**ADDENDUM 1**

**CITY OF AMES**

**PROJECT:** Freel Drive Paving

**ADDENDUM NUMBER:** 1

# PROPOSED PRESSURE REDUCING VALVE PIT

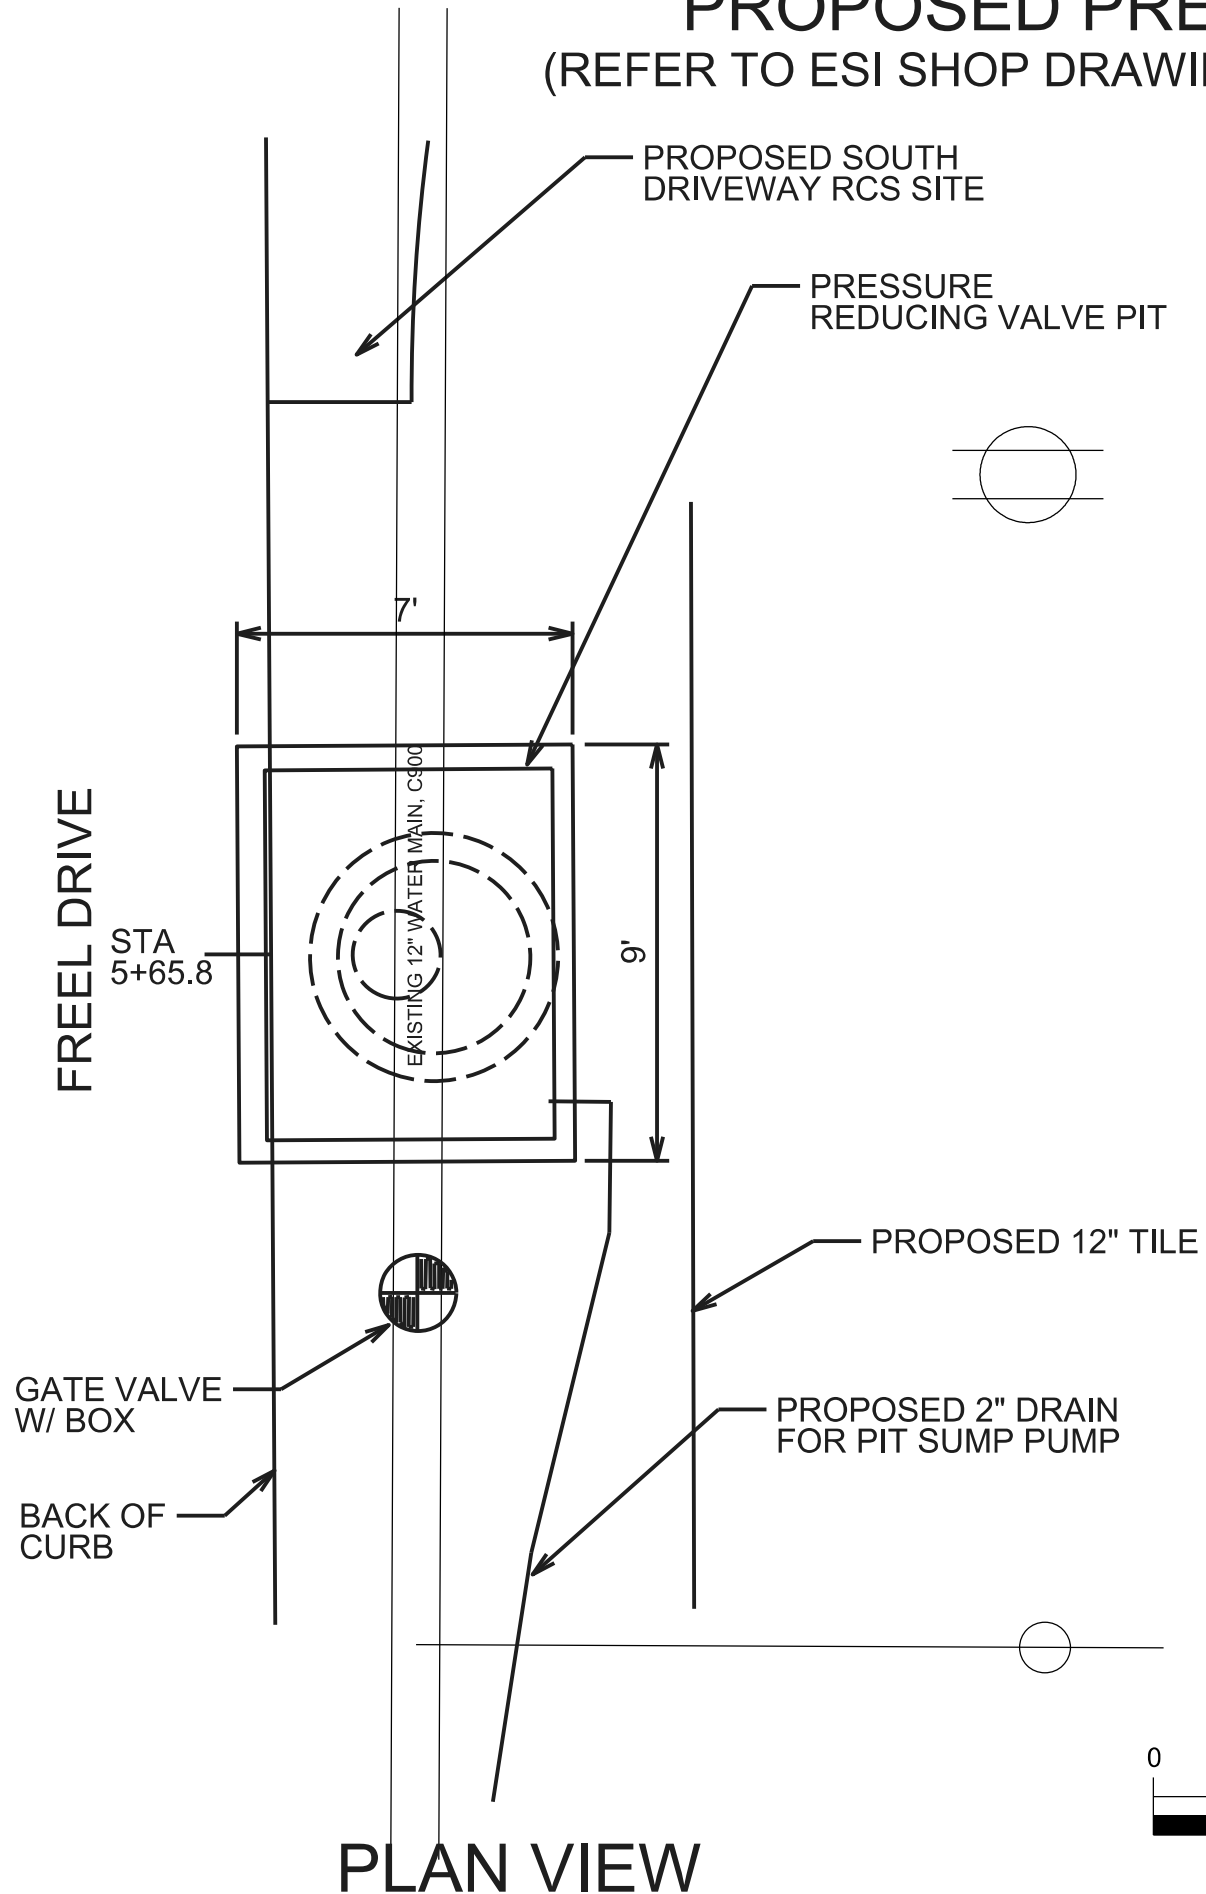
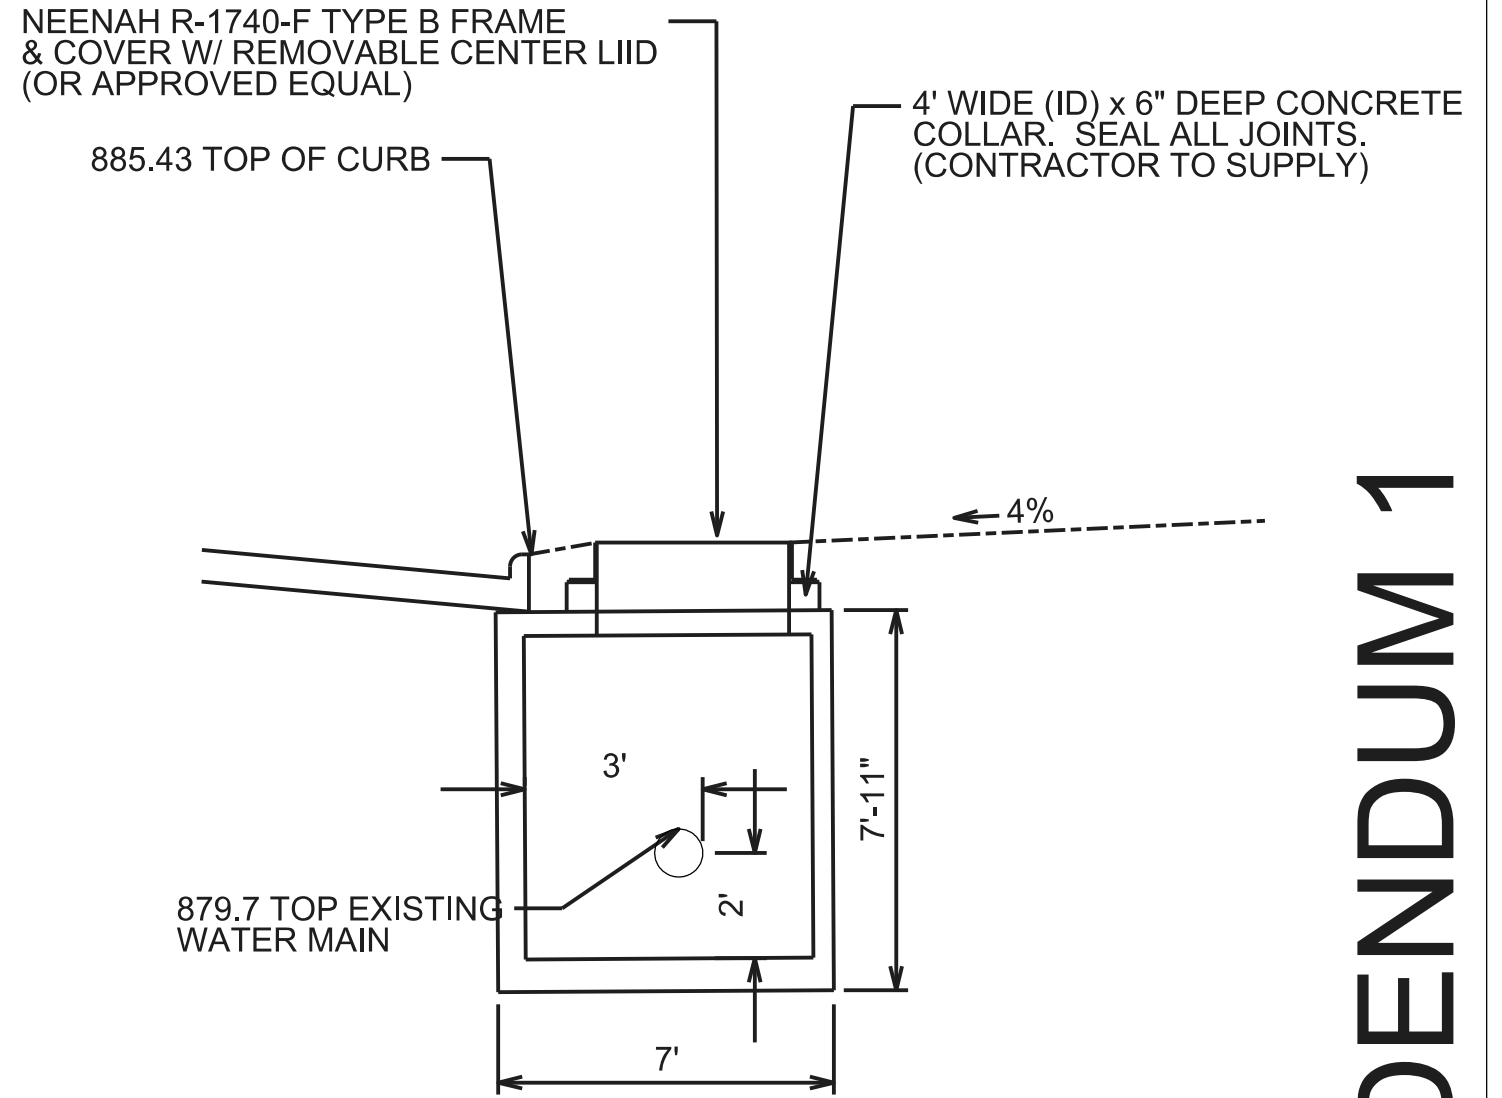
Item **5.7 Pressure Reducing Valve, Installation, complete**, has additional sheets B.03, B.04 and information regarding this installation.

5.7 **5020-A PRESSURE REDUCING VALVE, INSTALLATION (EA).** Unit price includes, but is not limited to, all components attached to the valve or required for its complete installation and operation as per the manufacturer installation and start up instructions. See sheet B.03 and B.04 for additional details. This bid item includes all the pipe and accessories necessary to connect to existing water main. The City will purchase the PRV package and have it stored at a City facility. The contractor will be responsible for transport and delivery to the construction site. Contractor will set structure shown on sheet B.03 and B.04.
